Review Date: SEPTEMBER 11, 1986

Report Date: NOVEMBER 1986

JEREMY DEVELOPMENT CORPORATION SUBDIVISION
LISBON, CONNECTICUT

ENVIRONMENTAL REVIEW TEAM REPORT
 ON
THE JEREMY DEVELOPMENT CORPORATION SUBDIVISION
LISBON, CONNECTICUT

ROLAND J. HARRIS & ASSOC. Land Surveyors - Civil Engineers - Land Planners GRISWOLD CONNECTICUT	
	PRELIMINARY SUBDIVISION PLAN PREPARED FOR THE JEREMY DEVELOPMENT CORP. ROSS HILL RD & RTE #169 LISBON, CT.	
SCALE 1"=200'	DATE JULY, '80	IDENT. NO. 86-761

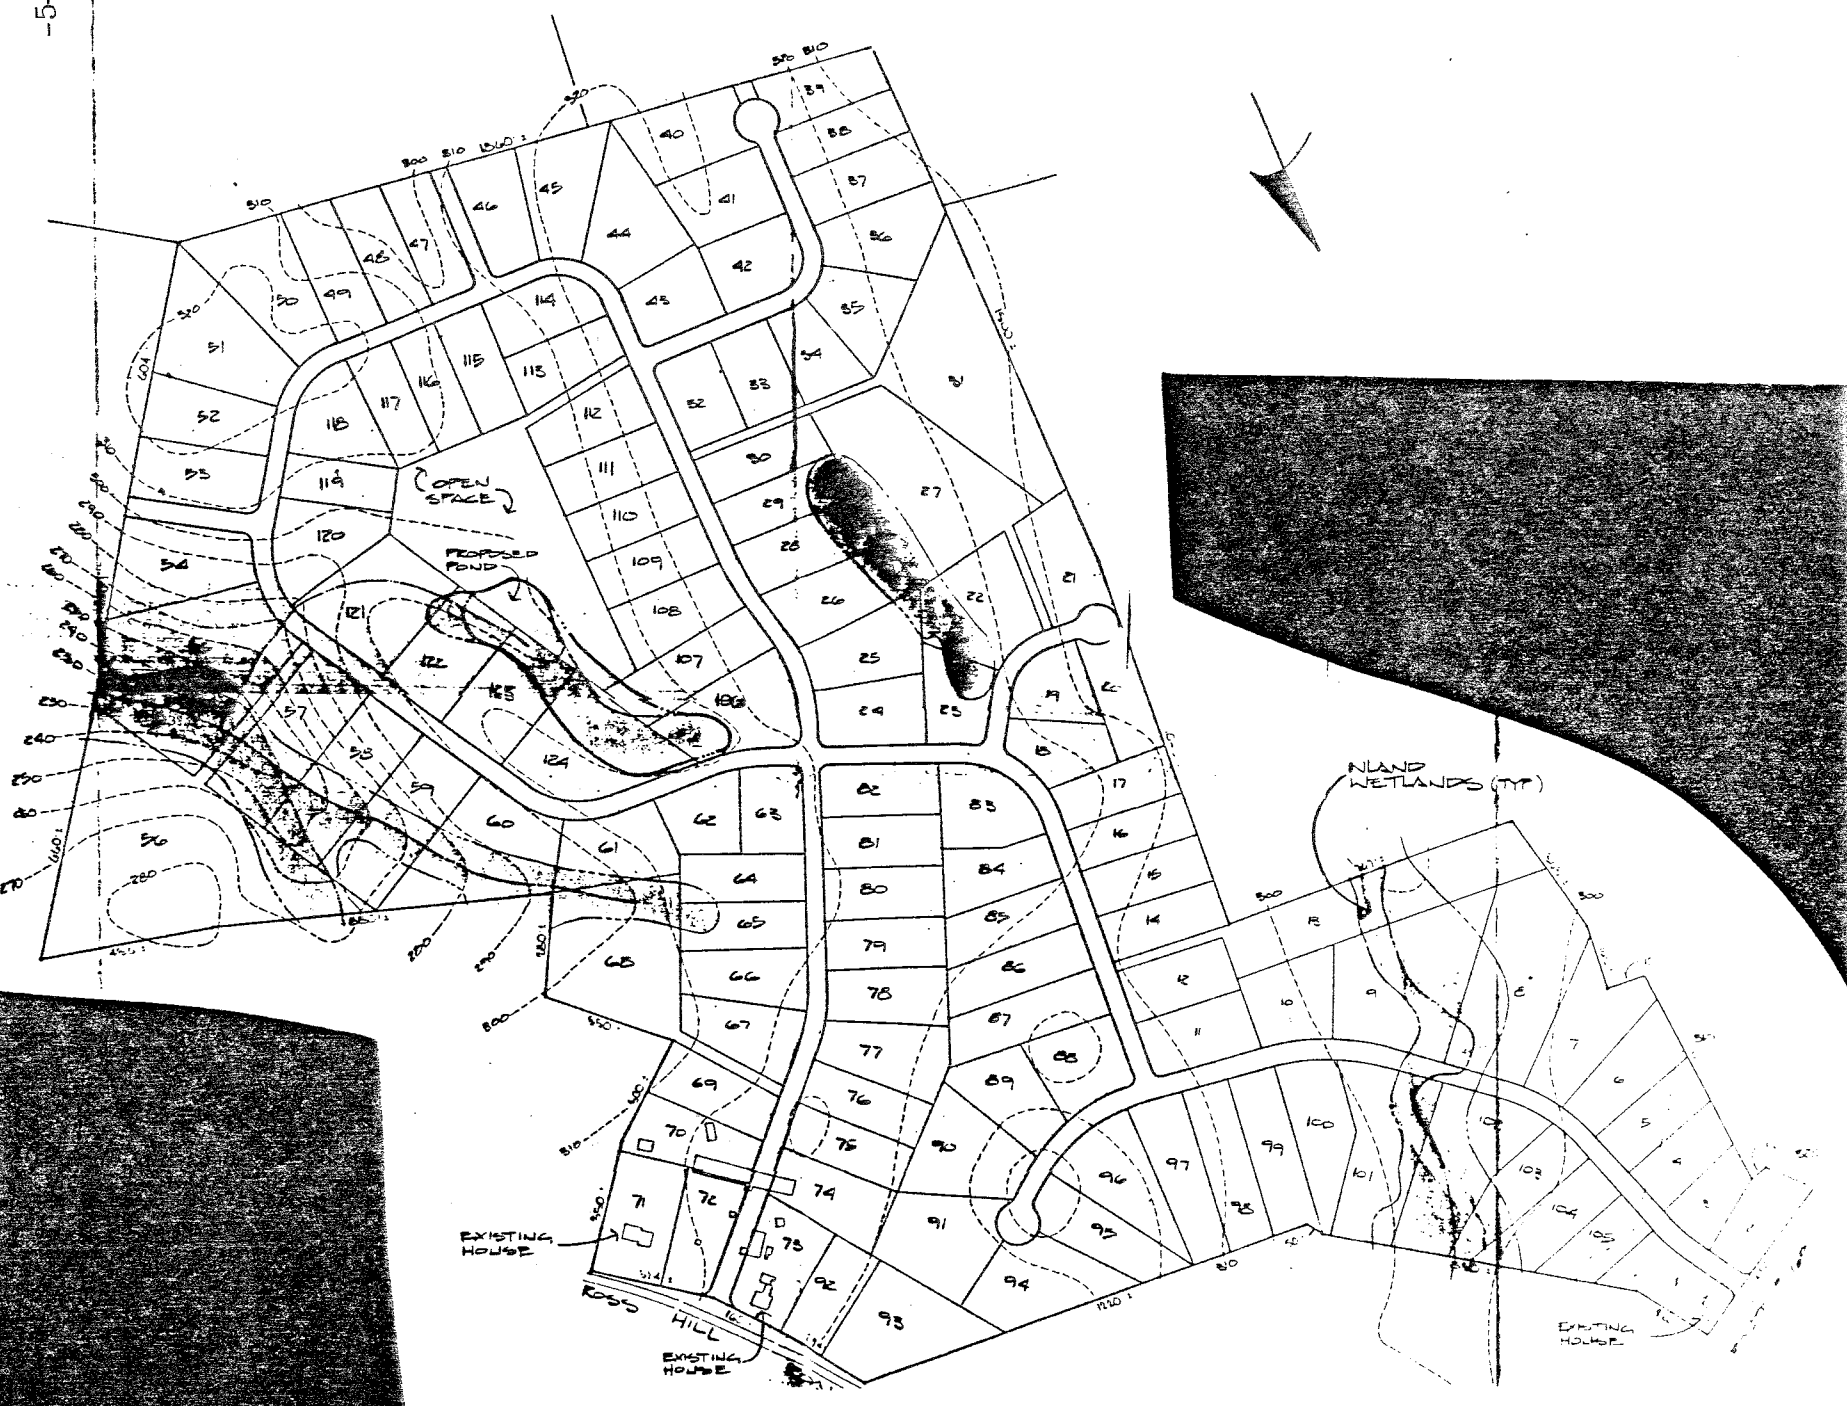
Preliminary subdivision plans have been prepared by Roland Harris & Associates for approximately 125 lots. The area is presently zoned for 40,000 minimum square foot lots. Approximately 10,000 linear feet of new road will be constructed through the site. Although the consulting firm has made a number of soil test holes, delineation of wetlands and other limiting site factors apparently have not been taken into full account. (As of the review date September 11, 1986.)

According to present plans, each of the proposed lots would require on-site septic systems and individual water supply wells. Although the applicant's engineer stated that approximately 120 deep test pits have been excavated throughout the site, mainly for determining the suitability for on-site sewage disposal systems, the results of the deep test hole were not made available to Team members except through verbal communication with the project engineer on the review day.

Based on present plans, it appears that inland-wetland soils will need to be crossed in order to construct the proposed interior road system and driveways, depending upon house locations.

It also appears that a number of possible lots in the subdivision will require detailed engineering plans for the sewage disposal system. It may also be necessary to make realignments of the present preliminary layout, which could lead to a reduction in the number of overall lots on the site.

--Wetlands on the site should be flagged in the field and surveyed onto the proposed plan.

-It appears that a number of the lots in the subdivision will require detailed engineering plans for sewage disposal systems. It may be necessary to realign the present layout which could result in a reduction in the overall number of lots.

New London Soil Survey Sheets #11 & #12

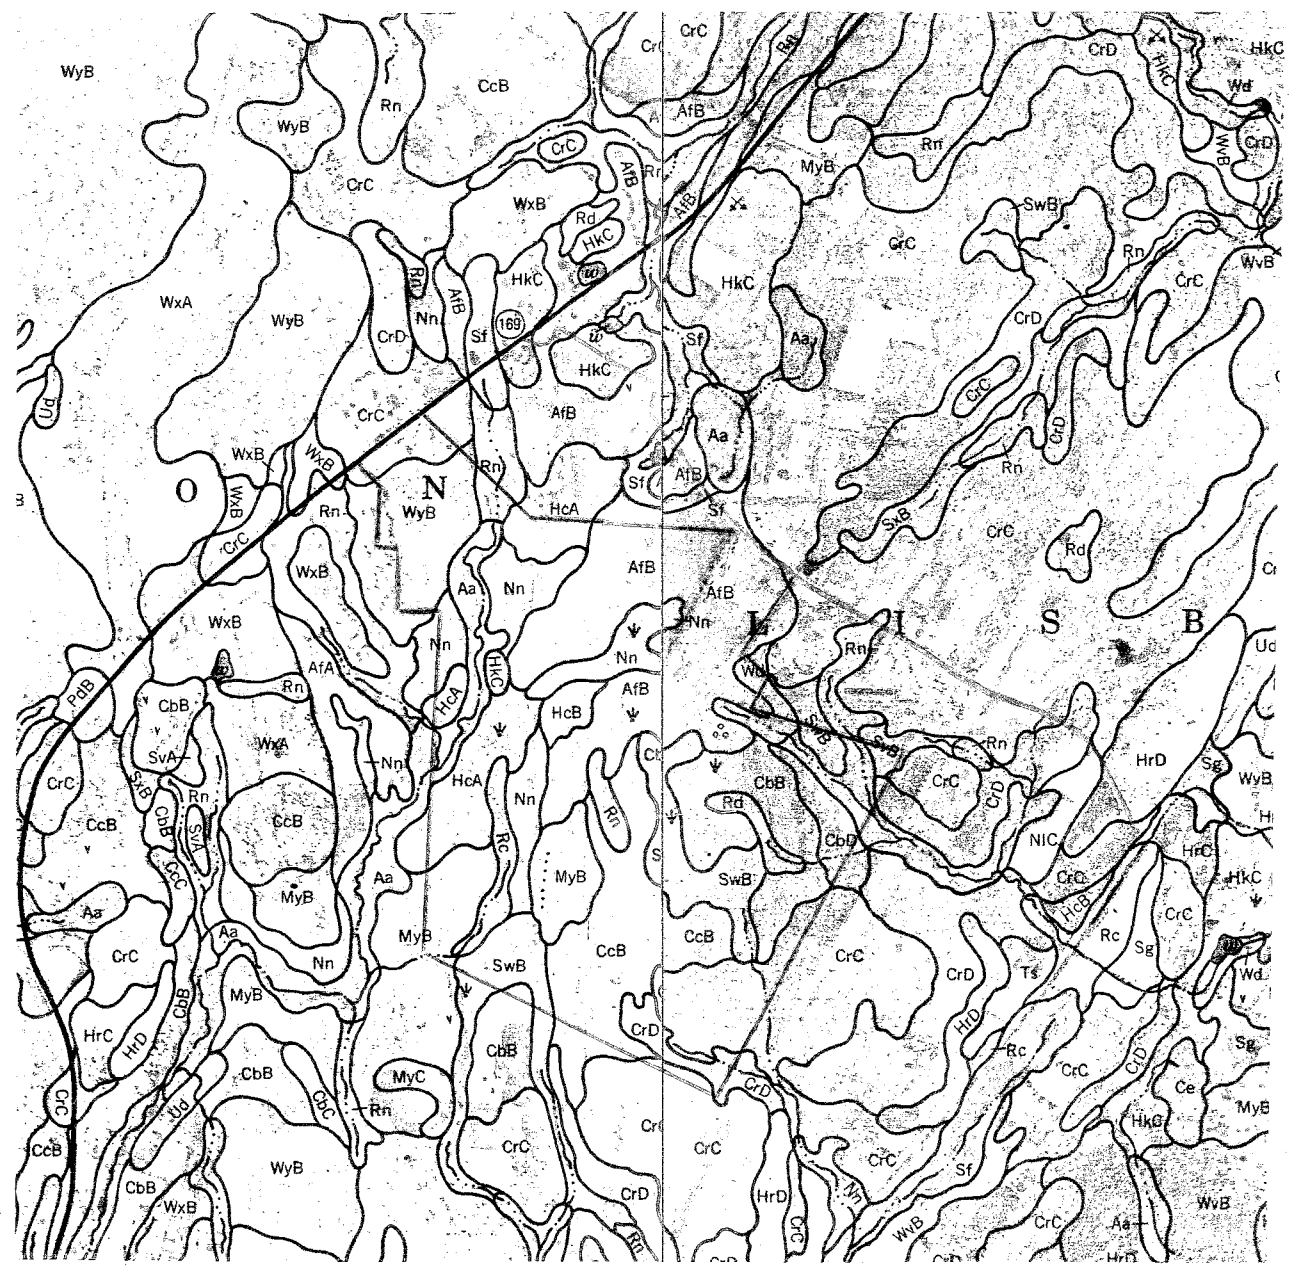
The attached soil map is from pages 11 and 12 of the New London County Soil Survey Report. There are a number of wetland soils on this parcel of land that are not indicated on this map. It is recommended that detailed flagging of wetlands be done in the field and subsequently surveying the flag numbers and wetland boundaries onto the developer's plot plan. A plan such as this will give the Town commissioners a better prospective of how the house lots and septic systems will relate to the wetlands. Septic systems will be sized based on site specific perc test data.
